MP 06_0118 Ferngrove Ballina Modification Report

Lot 121 of DP 1205071 - Located at Elkhorn Parade, Ballina

14 September 2015

PLAN SHOWING DIMENSIONS AND AREAS

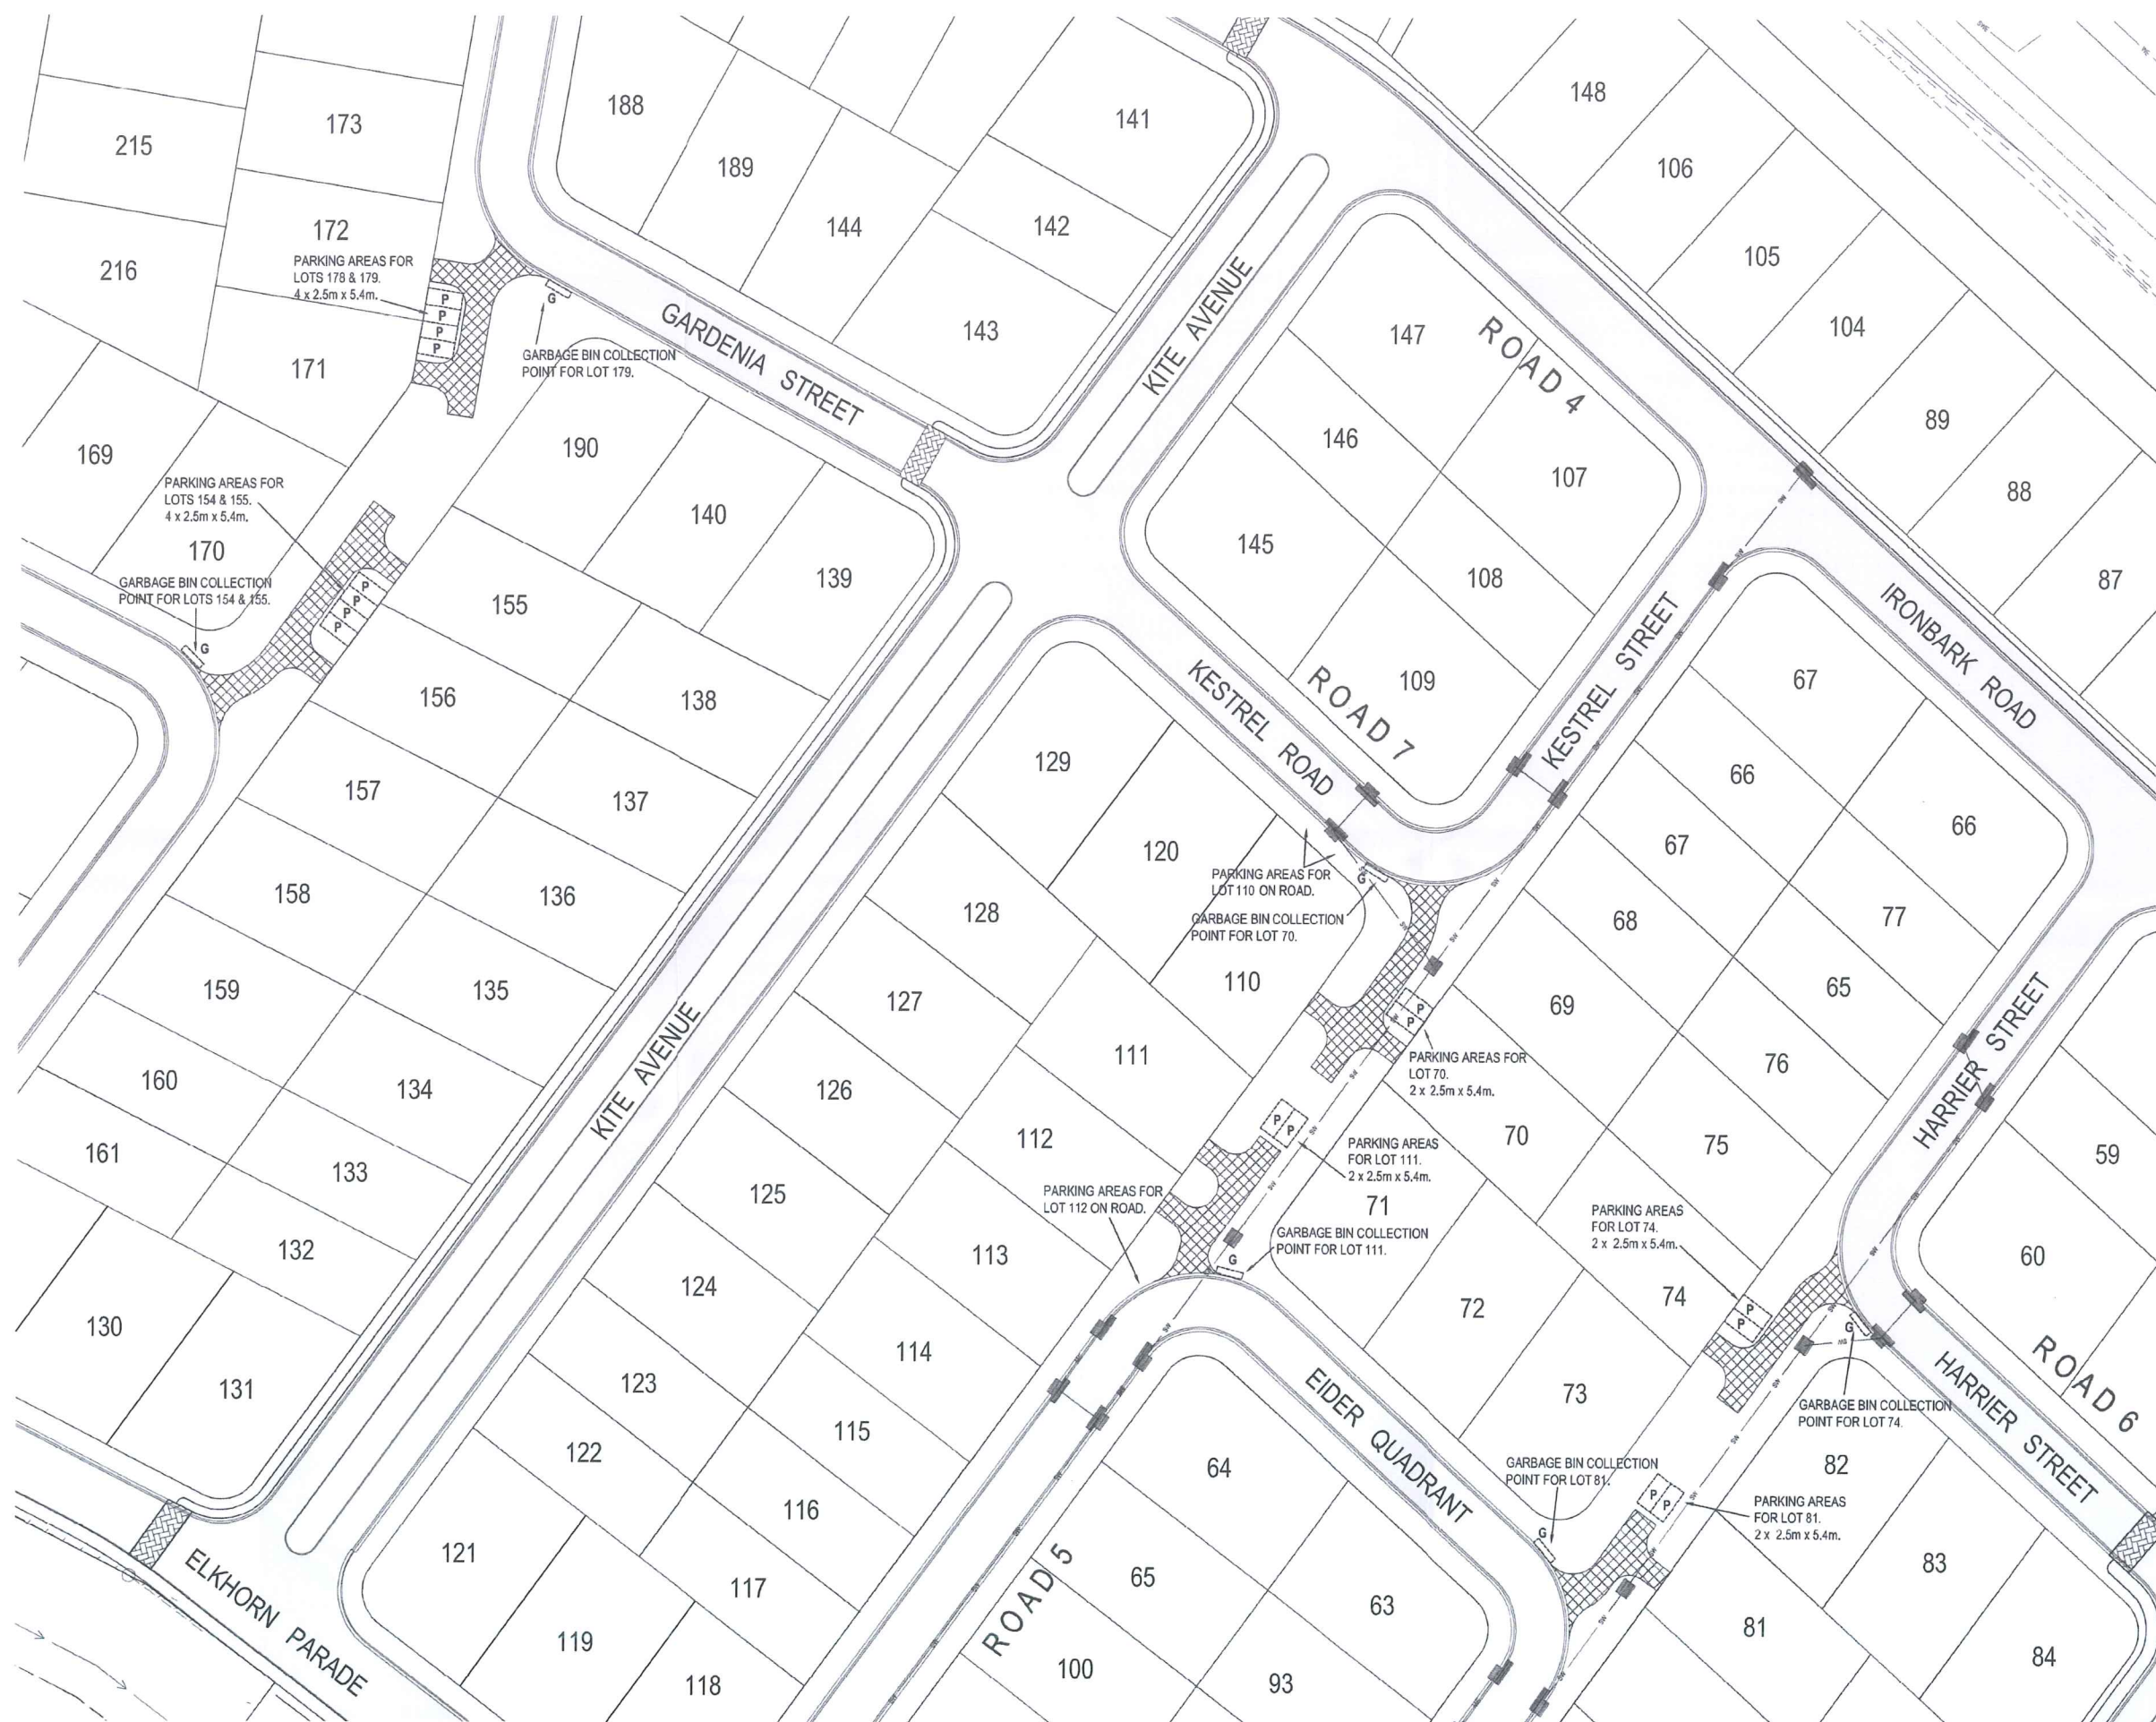
The modification to the approved lot numbers is required given that NSW Land and Property Information cannot register plans which have inconsecutive lot numbers. The original approved development included lot numbers which were not consecutive. As such, the lot numbers have been amended as shown below in **Tables 2.2, 2.3, 2.4, 2.5, 2.6, 2.7 and 2.8**, and the modified plans included in **Appendix A** of this report.
